NPL 94-0237

DOCKETS 50-266 AND 50-301
RESPONSE TO REQUEST FOR ADDITIONAL INFORMATION
REGARDING THE INSTALLATION OF TWO ADDITIONAL
EMERGENCY DIESEL GENERATORS (TAC NOS. M87865 AND M87866)
POINT BEACH NUCLEAR PLANT, UNITS 1 AND 2

RESPONSE TO THE REQUEST FOR ADDITIONAL INFORMATION
REGARDING THE INSTALLATION OF TWO ADDITIONAL
EMERGENCY DIESEL GENERATORS (TAC NOS. M87865 AND M87866)
POINT BEACH NUCLEAR PLANT, UNITS 1 AND 2

19018	WISCONSIN ELECTRIC	P & ID FUEL OIL SYSTEM POINT BEACH N.P. UNIT 1
E. PB. 01MFOK00000124

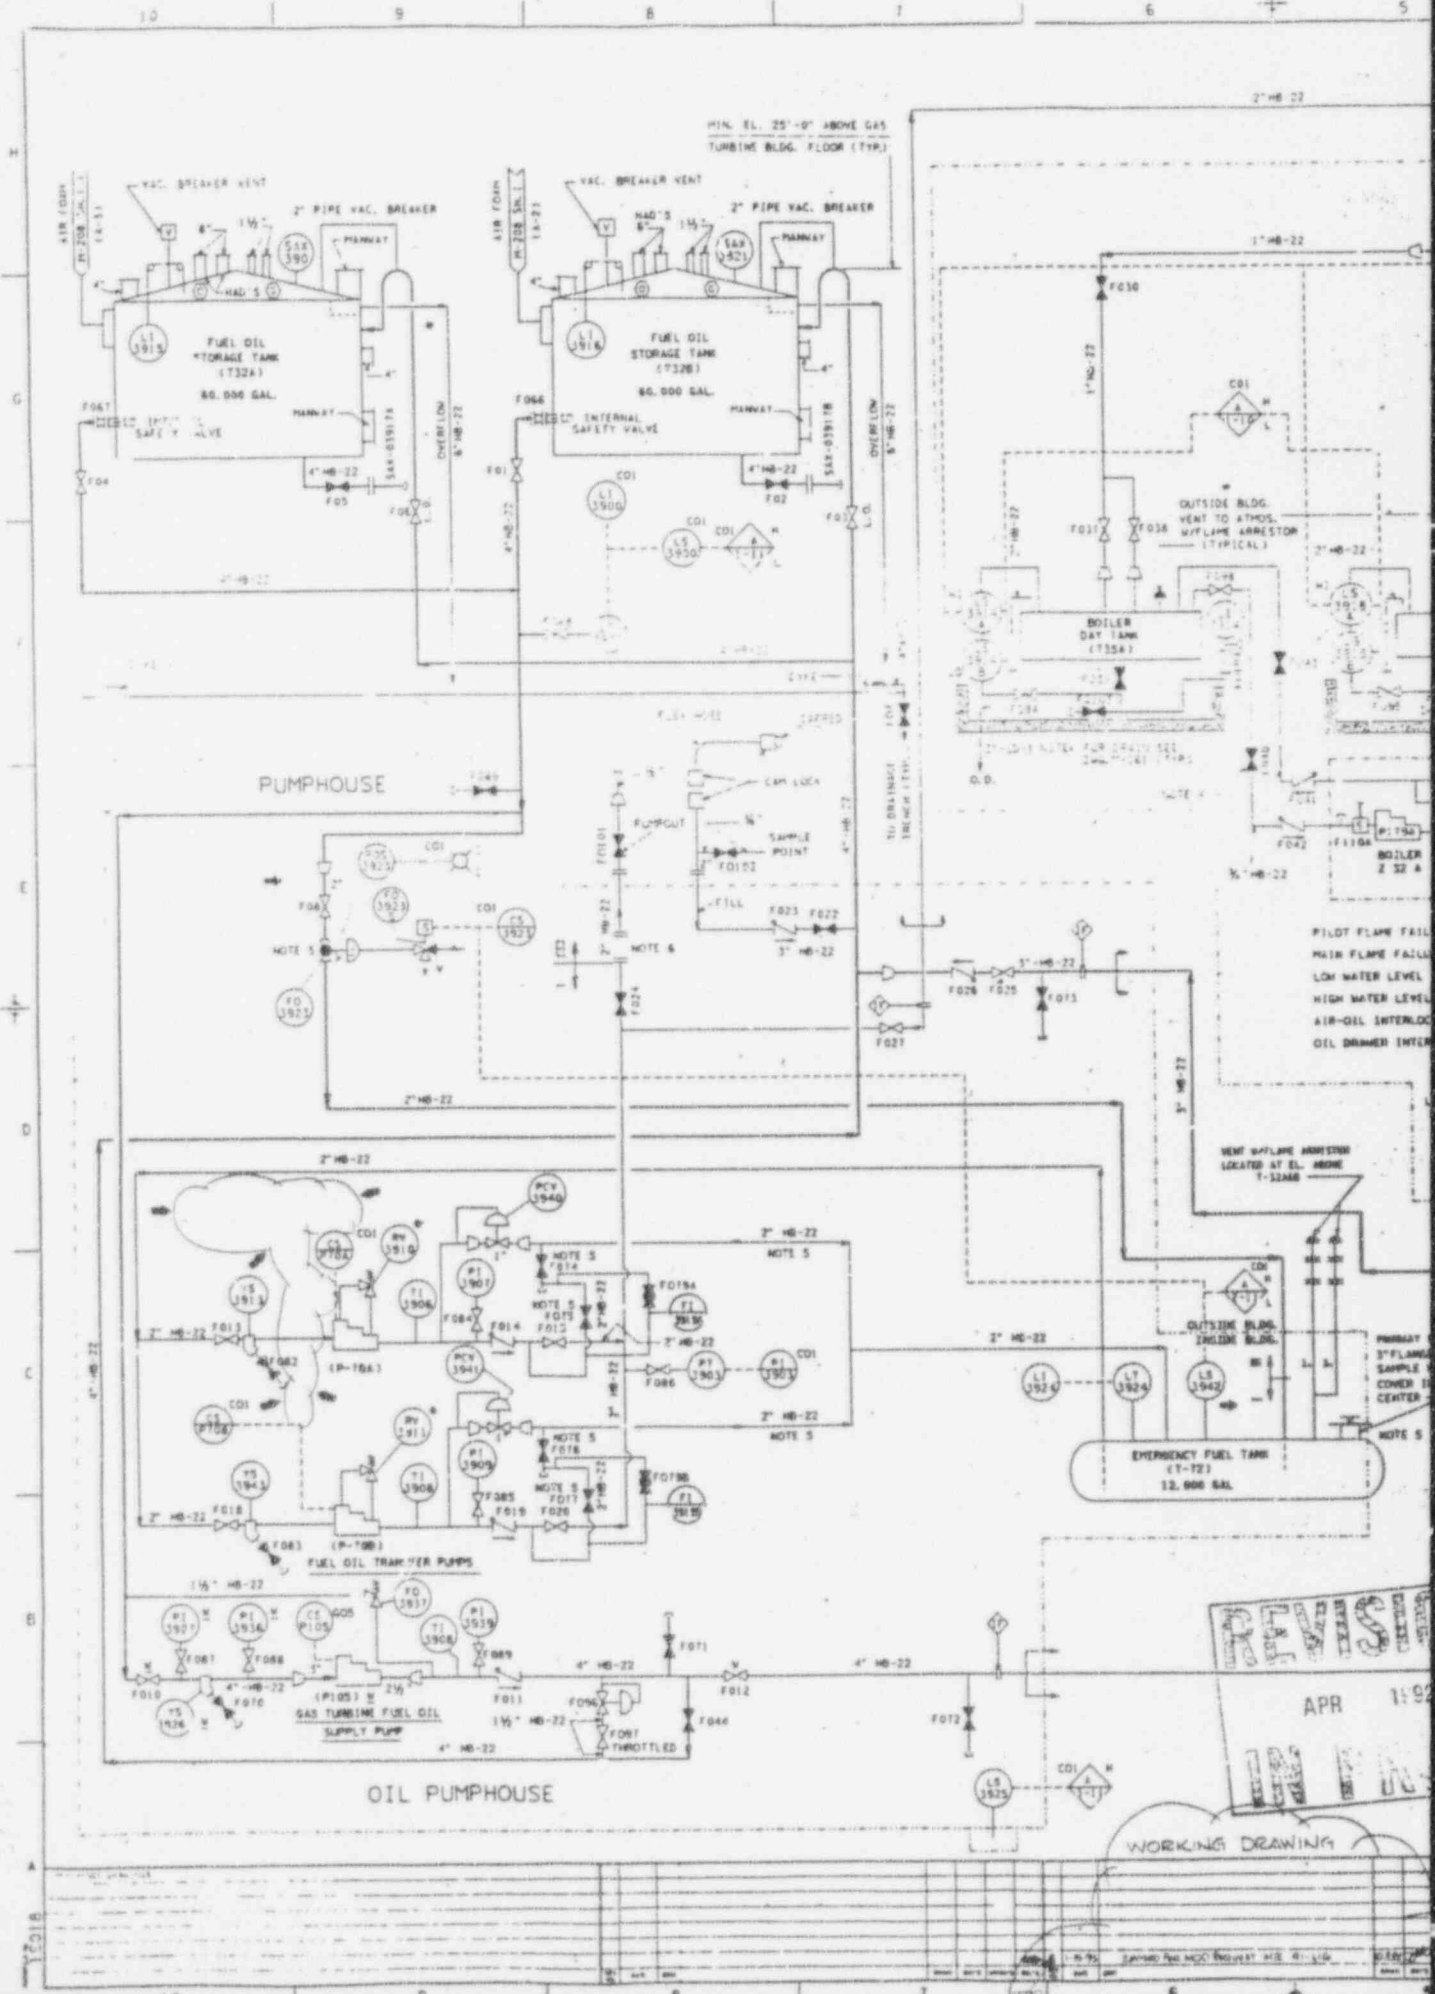
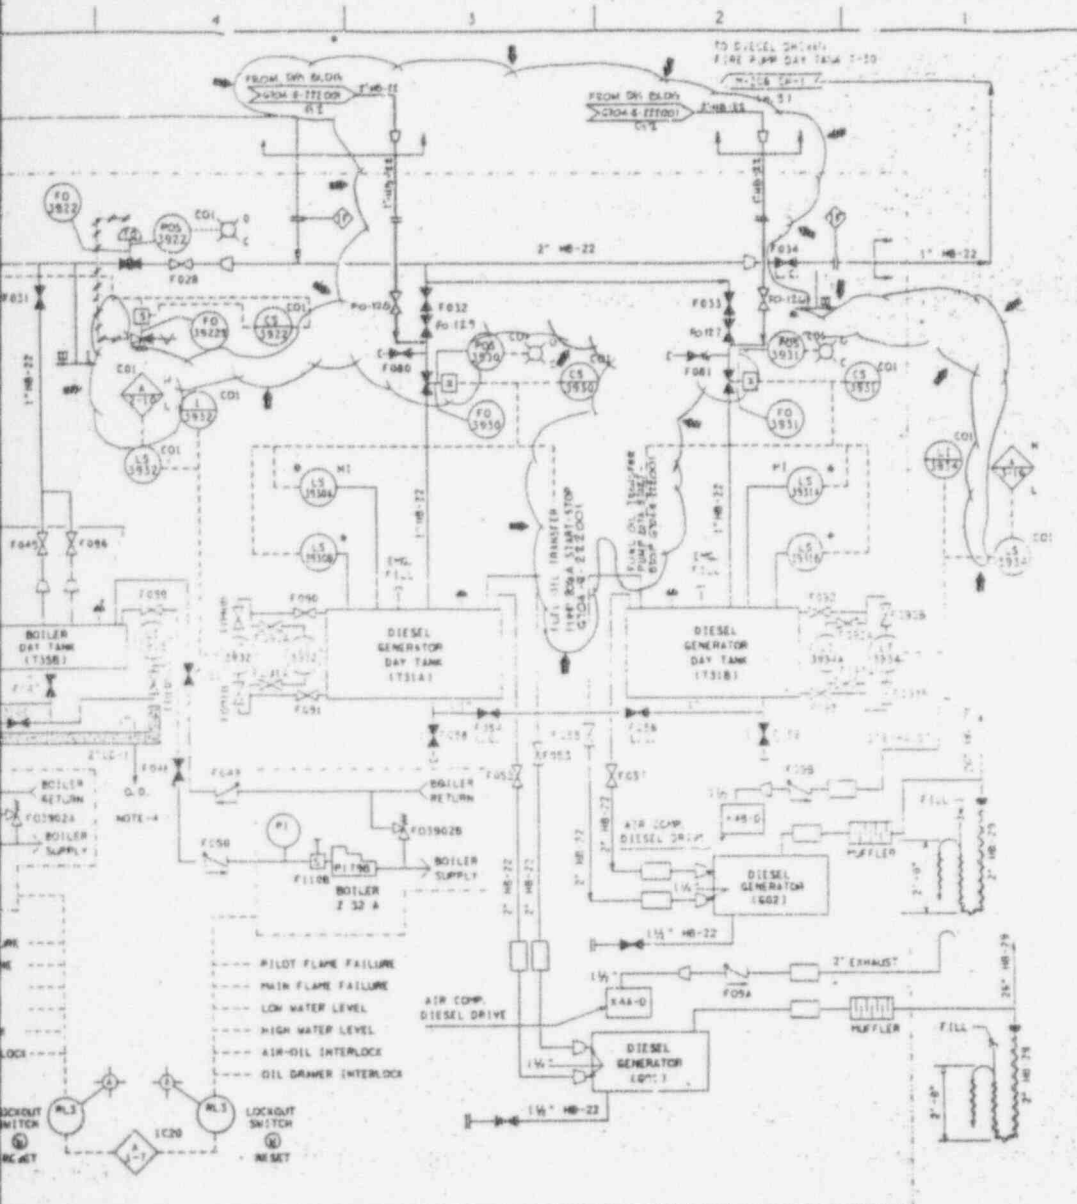
- b. You also indicated that cross-ties between the day tanks and between fuel oil storage tanks are provided to allow more flexible EDG operations. Provide: drawings/diagrams to show all the system cross-ties and the above cited dual system isolation valves; a detailed description of each mode of system operation; a commitment of the operating procedures to be developed for each mode of the system operation; and a description of the training plan for the licensed/non-licensed operators.

The above cited dual system isolation valves between the existing and new systems are shown in the attached fuel oil system drawing. The valves FO-32 and FO-129 will provide double valve isolation between T-31A (the EDG G-01 day tank) and the existing system. Valves FO-31 and FO-127 provide double isolation between T-31B (the EDG G-02 day tank) and the existing system.

Cross ties are provided between day tanks of the same train. These cross ties are shown in Figure 4-4 of the Design Summary for G03 and G04, and in the attached fuel oil system drawing for G01 and G02. There are two valves in each cross tie. These valves are shown as normally closed on the system P&ID and will be shown as normally closed on the system valve checklist.

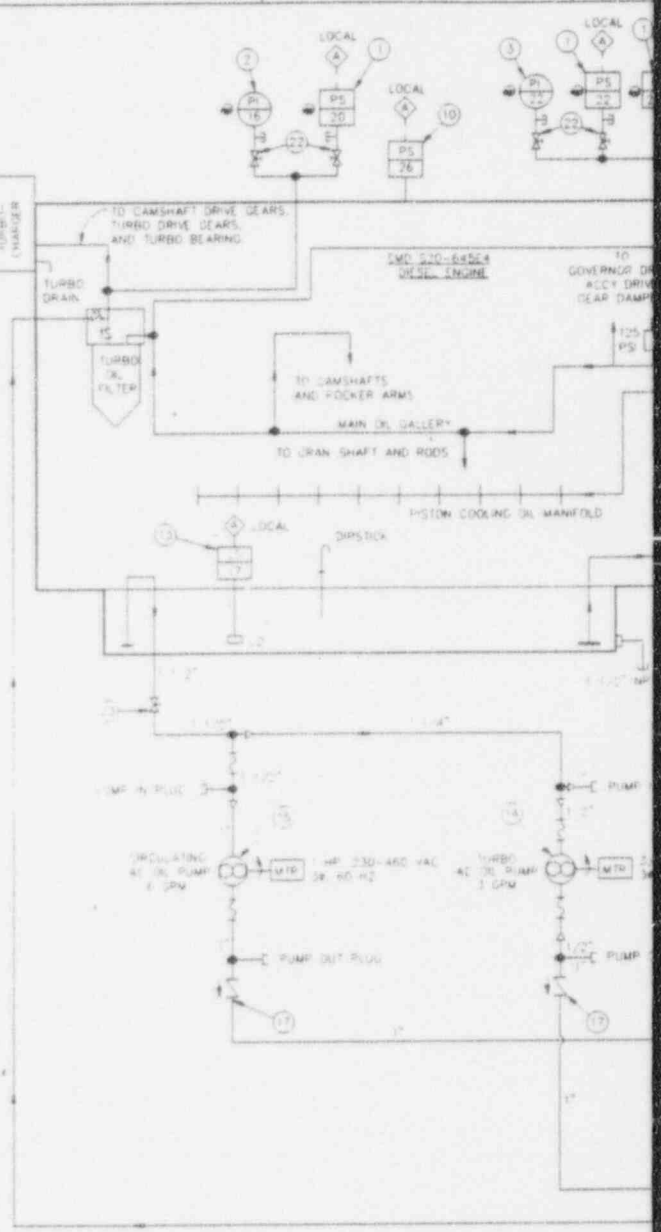
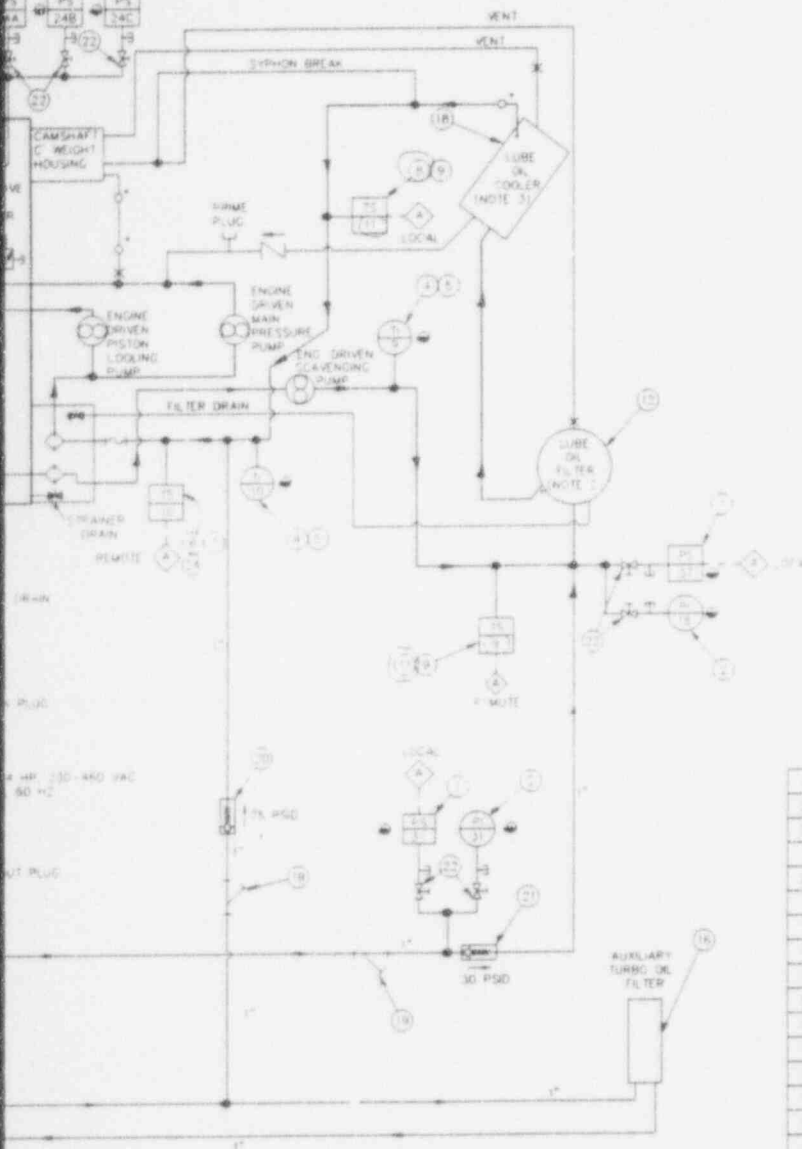
- 4.0 With regard to the diesel engine lubrication system, discuss the means provided for indicating and monitoring: oil levels, temperatures, and pressures at various points of the system; and the differential pressures across the oil strainers and filters.

The engine lubricating system is a combination of four separate systems as seen on the attached lubricating oil system piping and instrument diagram 6090F03001. These systems are the main lubricating system, piston cooling system, scavenging oil system and circulating oil system.

The following pressure and temperature switches have been incorporated into the lube oil system to monitor system performance:

PS-3353	LOW TURBOCHARGER OIL PRESSURE
PS-3352	LOW ENGINE OIL PRESSURE
PS-3351, 3355, 3356	LOW ENGINE LUBE OIL SHUTDOWN (2 OF 3)
PS-3350	HIGH CRANKCASE PRESSURE
PS-3357	LOW CIRCULATING OIL PRESSURE
PS-3349	HIGH OIL FILTER INLET PRESSURE
TS-3348	LUBE OIL FILTER BYPASS TEMPERATURE
TS-3347	LOW LUBE OIL TEMPERATURE
TS-3346	HIGH LUBE OIL TEMPERATURE

LS-3354 provides an indication of a low oil sump level. Activation of the low lube oil level alarm indicates that approximately 257 gallons of lube oil is required to return the oil level to the full level.
